Access Compliance Report

Public Rights-of-Way

(Curb Ramps)

Intersection ID: 10025341	Main Street: E_7TH_ST	Cross Street: N/A	Location: S
ADA ID: 26E183CC8AAC	Ramp Type: Directional1	Initial Pass/Fail: Fail	Overall Compliance: No
		Severity Score: 12.5

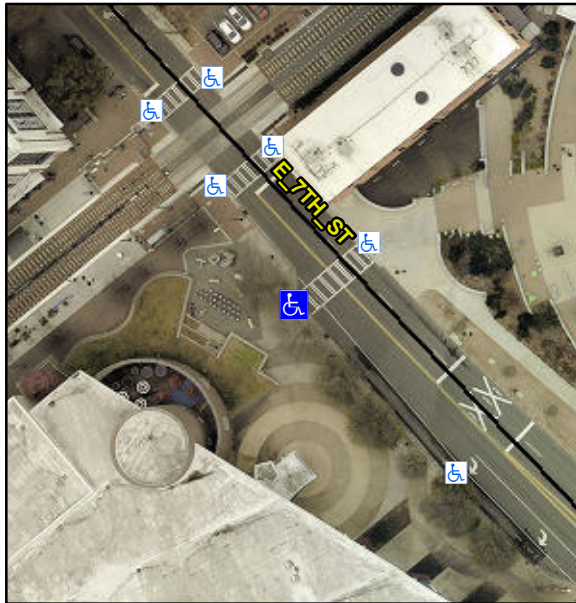
R304.2.2

Compliance	Description	Data	Compliance	Description	Data
N/A	Ramp Length (in)	72.0	N/A	Grade Break?	N/A
Yes	Ramp Width (in)	96.0	N/A	Grade Break Slope (%)	0.0
No	Ramp Slope (%)	9.3	N/A	Grade Break XSlope (%)	0.0
Yes	Ramp XSlope (%)	1.7			
N/A	Flare Type LT	N/A	N/A	Flare Type RT	N/A
N/A	Flare Slope LT (%)	N/A	N/A	Flare Slope RT (%)	0.0
N/A	Flare Traversable LT?	N/A	N/A	Flare Traversable RT?	N/A
N/A	Landing Length (in)	0.0	N/A	DWS Provided?	N/A
N/A	Landing Width (in)	0.0	N/A	DWS Contrast?	N/A
N/A	Landing Slope (%)	0.0	N/A	DWS Length (in)	N/A
N/A	Landing X Slope (%)	0.0	N/A	DWS Full Width?	N/A
N/A	Landing Curb? (Y/N)	N/A	N/A	DWS Offset LT (in)	N/A
N/A	Shared Landing?	N/A	N/A	DWS Offset RT (in)	N/A
N/A	Gutter Ponding?	0.0	N/A	Gutter Slope (%)	N/A
N/A	Gutter Lip Ht (in)	0.0	N/A	Gutter X Slope (%)	N/A
N/A	Painted X Walk1?	Yes		Road Slope (%)	3.8
	X Walk 1 Direction	To NE		Road X Slope (%)	4.2
	X Walk 1 Width (in)	142.0		Clear Space?	N/A

Remove & Replace Entire Ramp.
